AEA Technology
QSA Inc.

Safety Analysis Report for the Model 702 Transport Package

1992/2001(Rev 4) Model 702 SAR COMPARISON

**Drawing Changes from the 1992 SAR for the 702
(SAR Revision 4) 6 Jul 01**

A-1 **Model 702 Isotope Shipping Container Descriptive Assembly, R70290, 9 Sheets,
Revision K**

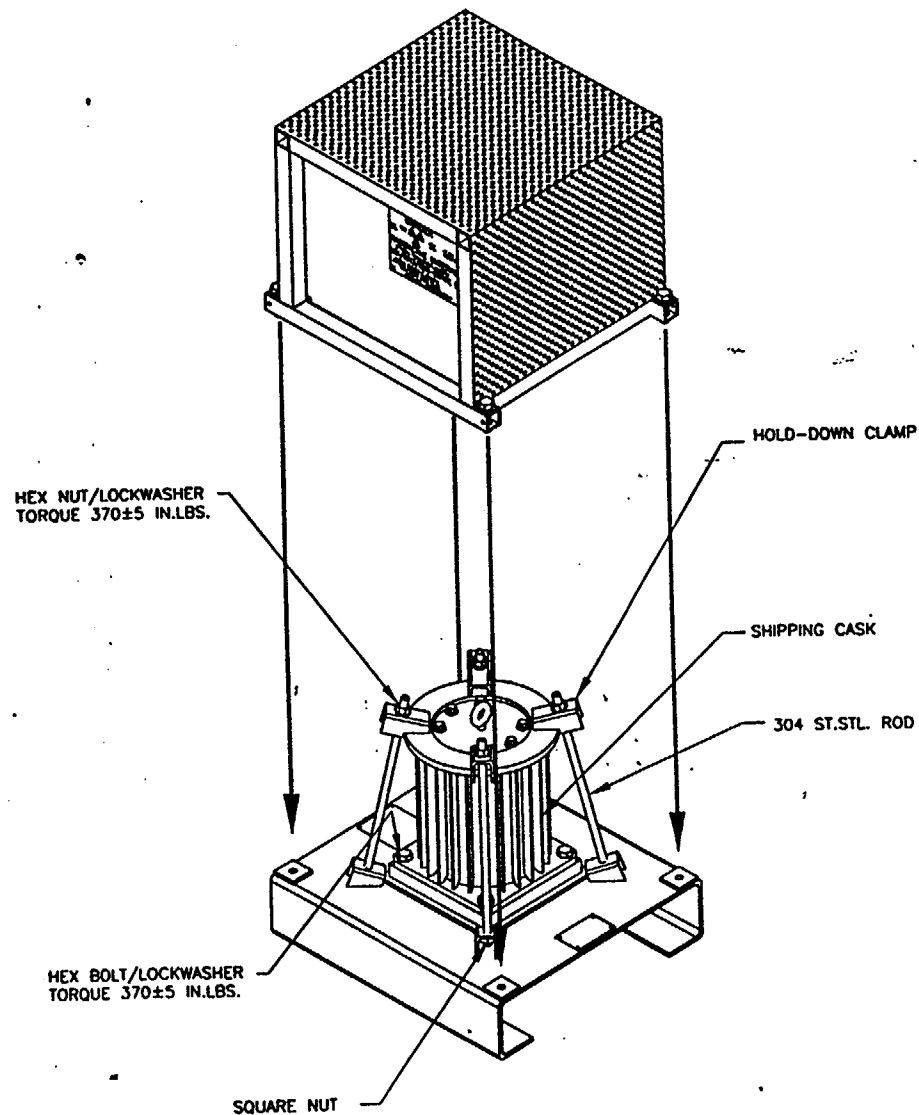
R70290, Sheet 1 of 9

- 1 Torque values for the cover bolts was changed from 517 in lbs to 370 in lbs. This change was made to reflect actual torque values used for these bolts which is based on standard practice guidelines of torquing bolts to 75% of the bolt yield strength. Test plan specimens were torqued to the value listed on these drawings.
- 2 A notation was added to reference welding reference requirements for all sheets in drawing R70290.
- 3 Physical dimensions for the 702 warning label are specified and the material thickness increased from 1/16" to 3/8" steel.
- 4 Steel type (304) for the cage plate specified.
- 5 A generic dimensional tolerance of 1/16" is added as well as specific tolerances for applicable dimensions.
